**Road Infrastructure Design Report**  
**Strategic Housing Development**  
**Baldoyle-Stapolin Growth Area 3,**  
**Baldoyle, Dublin 13**

**ROAD INFRASTRUCTURE DESIGN REPORT**

**STRATEGIC HOUSING DEVELOPMENT, BALDOYLE-STAPOLIN GROWTH AREA 3,  
BALDOYLE, DUBLIN 13**

**BS 1192 FIELD**      **BD-CSC-ZZ-G3-RP-C-0007-P4**

**4.4 Issue:**

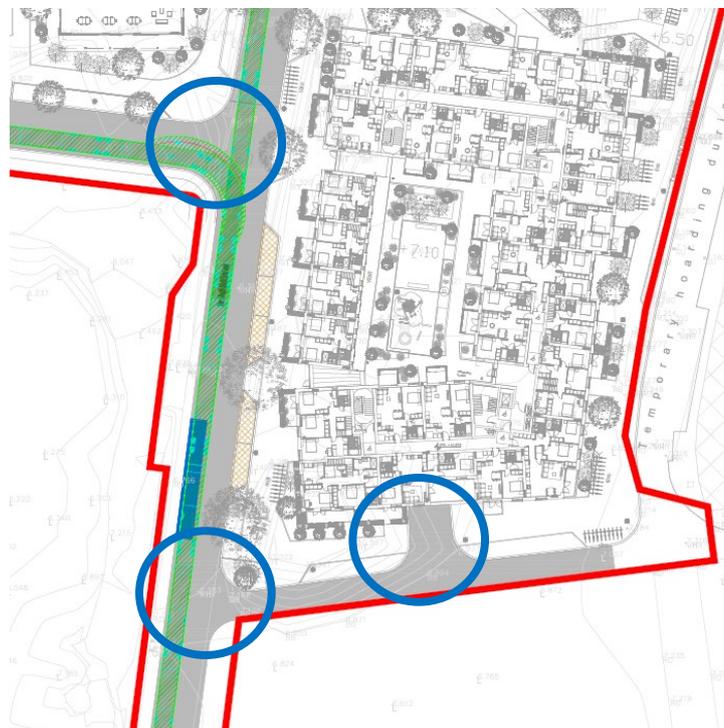
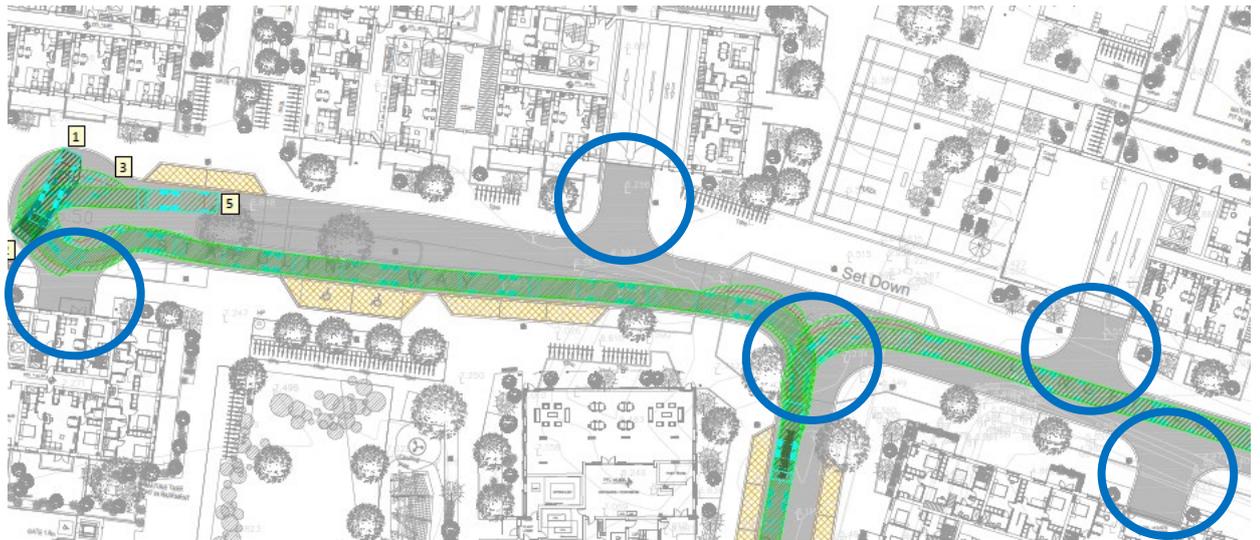
Crossing facilities such as dropped kerbs and tactile paving are not shown to be provided within the proposed development. A lack of an adequate pedestrian crossing may contribute to a pedestrian stepping out onto the carriageway at an unsafe location which may increase the risk of a collision between and pedestrian and drivers of vehicles.

Provide tactile paving and dropped kerbs at all crossing location to cater for the desired route for pedestrians.

4.8 Issue:

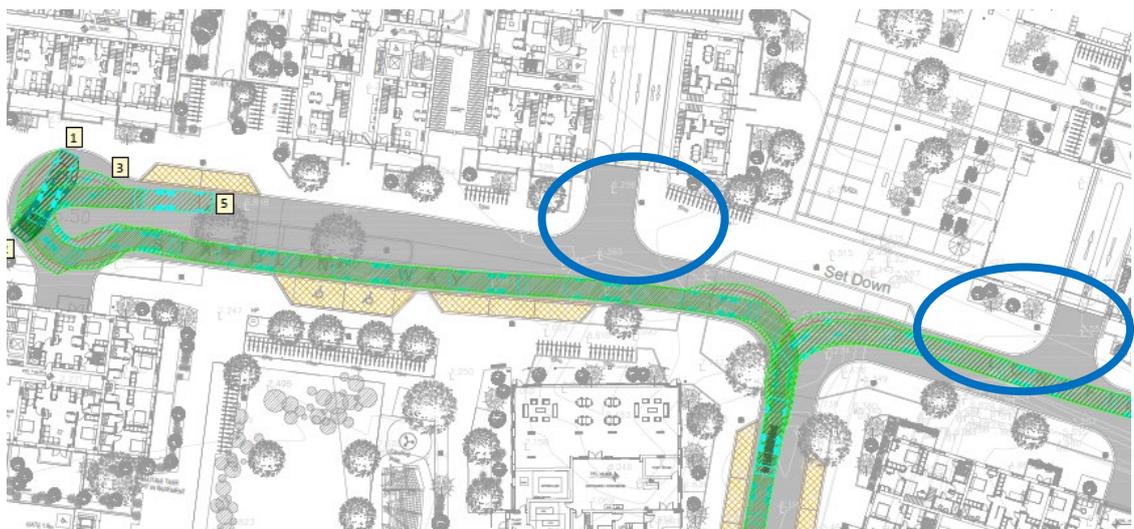
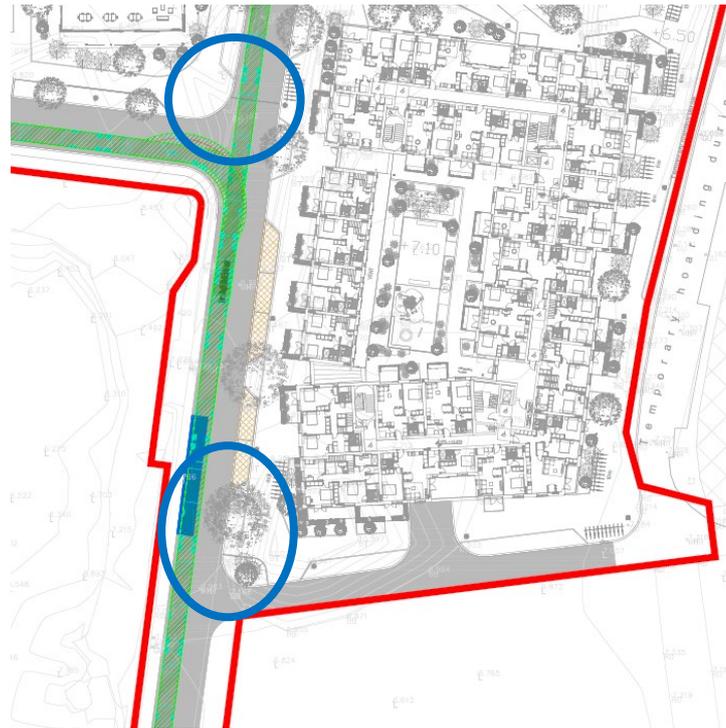
Street lighting is not shown to be provided within the proposed development. Road safety would be enhanced with the provision of street lighting.

Provide adequate street within the proposed development.

**4.10 Issue:**

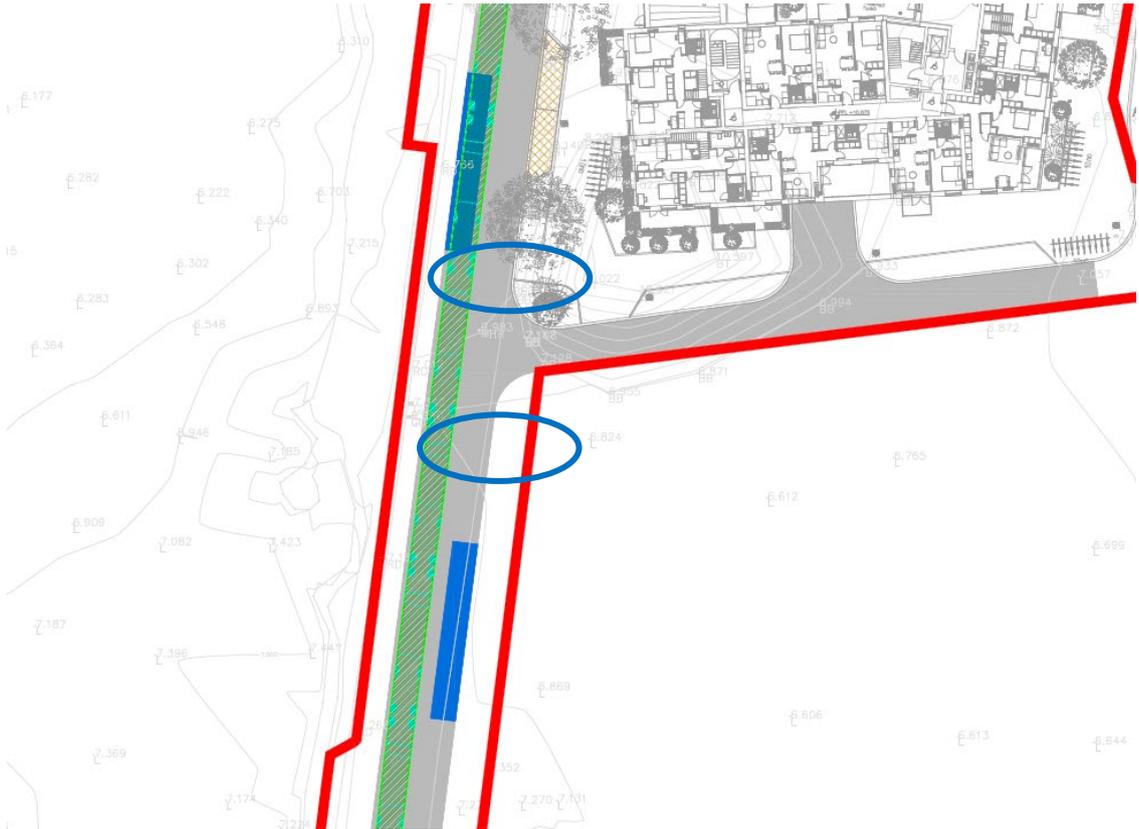
A number of pedestrian crossings are proposed adjacent to car parking spaces. However, it is unclear whether adequate inter-visibility is provided between drivers of vehicles approaching the pedestrian crossings and a pedestrian stopped waiting to cross at the pedestrian crossings. A lack of adequate inter-visibility may contribute to a collision at these locations.

Ensure adequate inter-visibility is provided between drivers of vehicles approaching the pedestrian crossing and pedestrians stopped waiting to cross.
